**SYDNEY MODERN PROJECT**  
**SUBMISSION ON MODIFICATION 4**  
**LANDSCAPING**  
**VERNON CURTILAGE**

## SYDNEY MODERN PROJECT SUBMISSION ON MODIFICATION 4 LANDSCAPING – VERNON CURTILAGE

*The inappropriate forecourt design in the original Development Application*

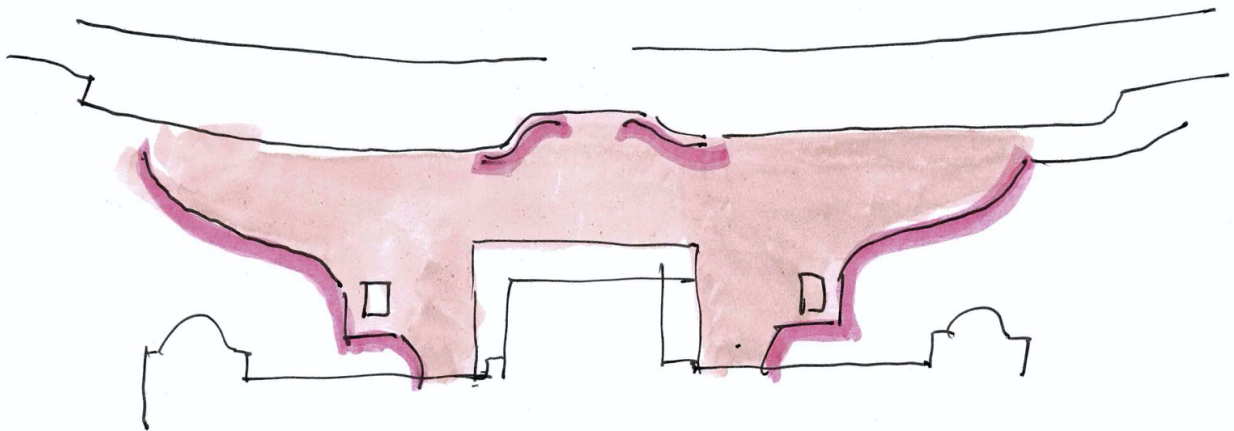
This design prevented approaching the building, on axis, from the city with a stone bench and planting bed between the street and portico. An enlarged area of pavement in front of the building offered no shade and little delight. Parts of the low stone “heritage” wall were to be “cut flush with the pavement level and bench seats were proposed, in one instance, as little as a metre away from the monumental Gilbert Bayes equestrian statues.

*The exhibited design for the Vernon curtilage*

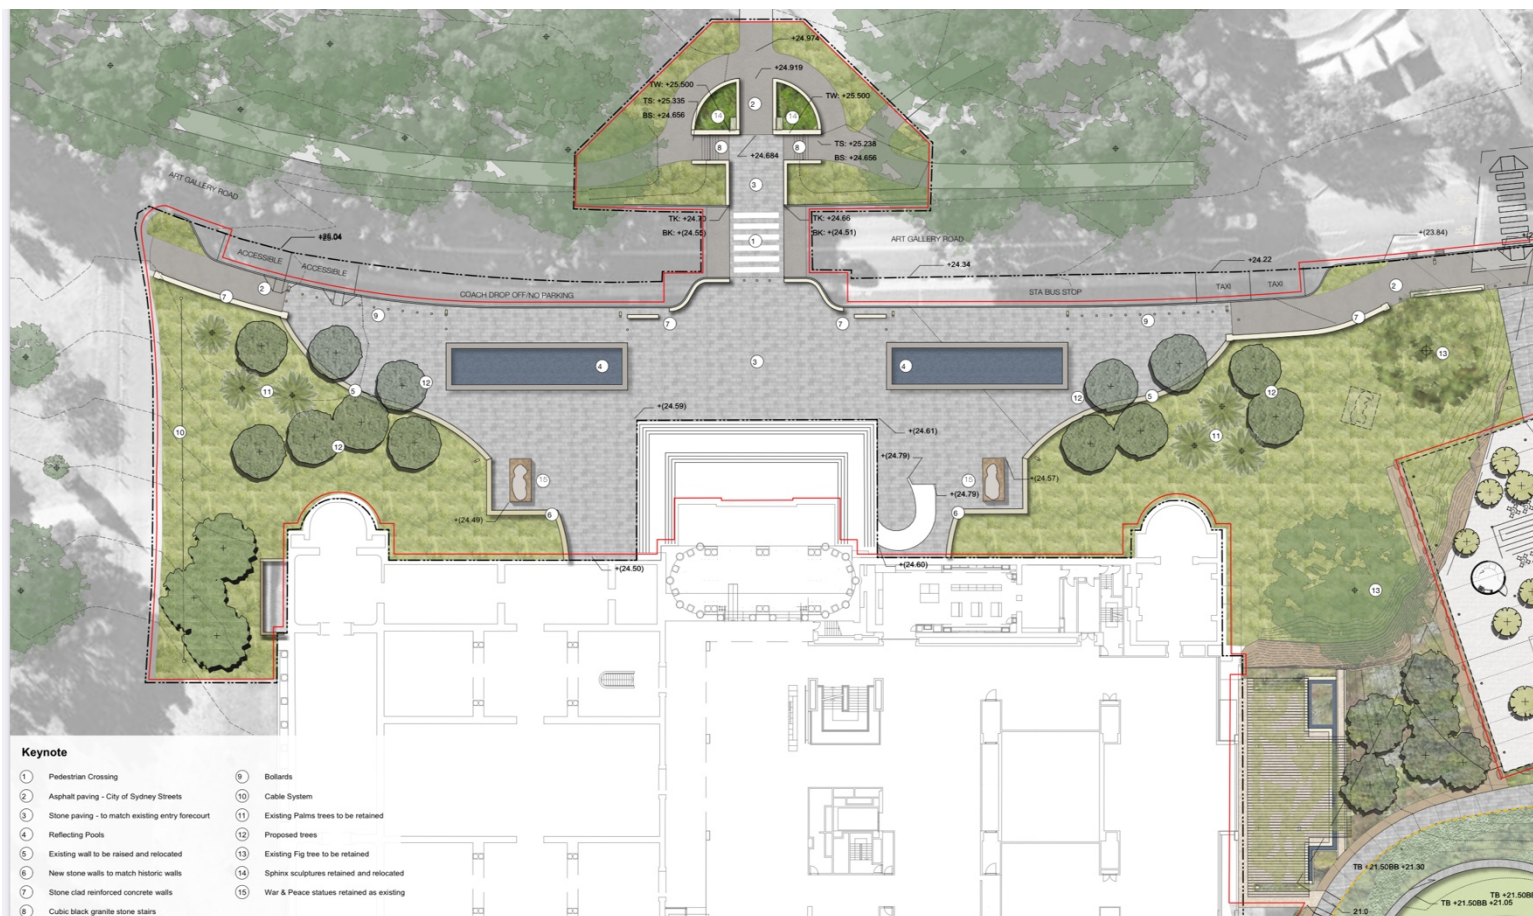
The bollards along the road alignment, the low walls adjacent to the pedestrian crossing and location of the reflecting pools all appear to be determined by the desire to prevent attacks by vehicles from Art Gallery Road.

While this may seem ingenious, it results in a number of unfortunate consequences. The low stone veneered walls, adjacent to the pedestrian crossing will be in the field of vision to the portico and detract from its appearance.

The location of the linear reflecting pools creates a 3-metre pinch point adjacent to the walls near the pedestrian crossing and 4 metres adjacent to the corners of the portico steps. While these dimensions are adequate for the needs of pedestrian movement they may appear mean given the overall scale of the forecourt.

The linearity of the reflecting pools has the effect of dividing the forecourt into separate roadside and building-side parcels reducing the appeal of the forecourt as a place for comfortable public gatherings.

It is felt that appropriate levels of security can be achieved by well-designed low stone bollards along the street alignment, freeing up the location of the reflecting pools and eliminating the need for the intrusive stone-veneered walls adjacent to the pedestrian crossing.

*Proposed rearrangement of pools and fir tree plants in forecourt to Vernon building*

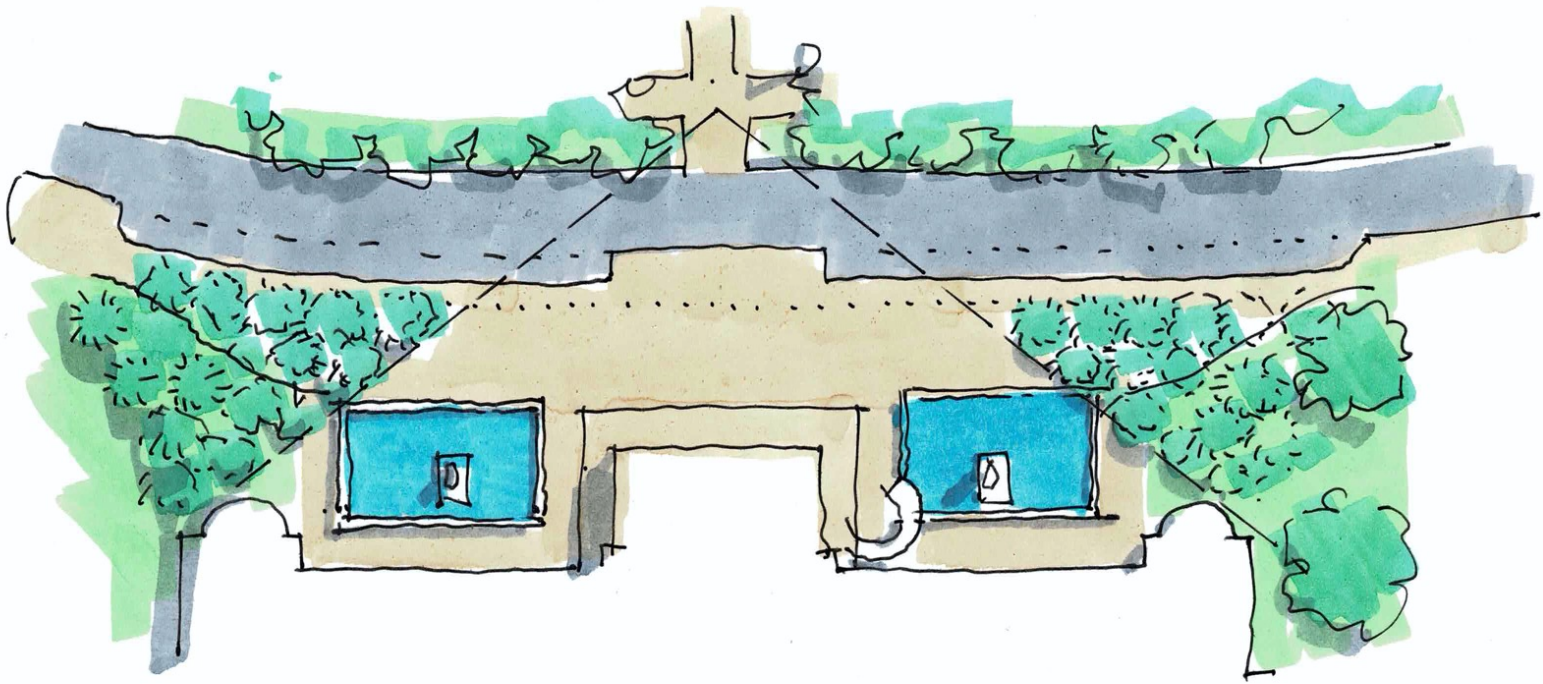
For these reasons, it is most pleasing to learn that reflecting pools are proposed at the AGNSW. However, it is suggested that they are in a different location, closer to the facade of the building and of a different shape factor as illustrated in the attached diagram.

The Bayes statues would rise from the pool, surrounded by water, but would be enhanced by their reflection. The greater east-west dimension of the pools would also make the reflection of the facade more effective. The edge of the reflecting pool should be designed to be suitable for sitting.

*Suggested reconfiguration of courtyard adjacent to basement level galleries to reinstate composition of north facade of Captain Cook Wing.*

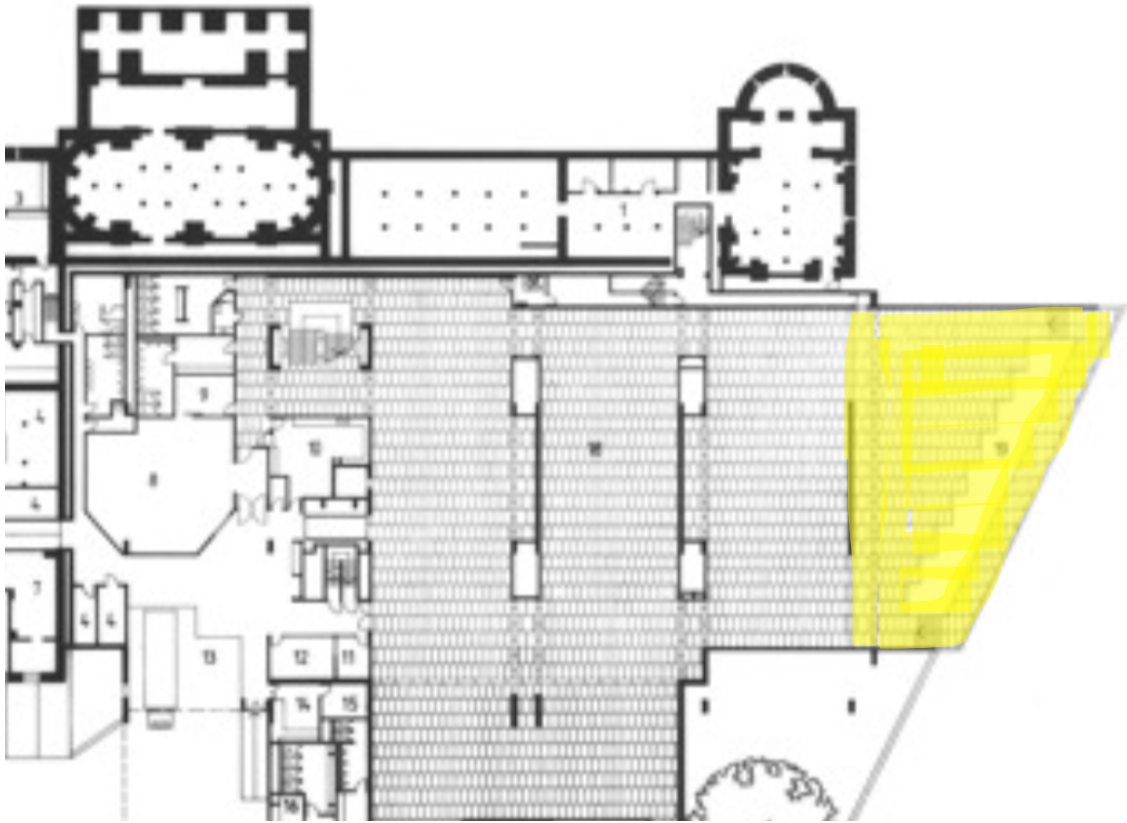
At the same time, the Gallery blocked the windows from the temporary exhibitions gallery and the ill-defined remnant of the space is now a blot on the curtilage. With the Sydney Modern project there is now a new focus upon this area, with the Gallery projecting up to open up views from the basement level below.

It would be most desirable that the landscaping design for this space could reinstate some of the lost spatial definition with landscaping elements such as trellises and vine covered screens for the architecture of the north facade to regain some of its meaning. It could be made secure to form an open-air display space through the vastly expanded display of Australian art now proposed on the basement and ground floor gallery levels.
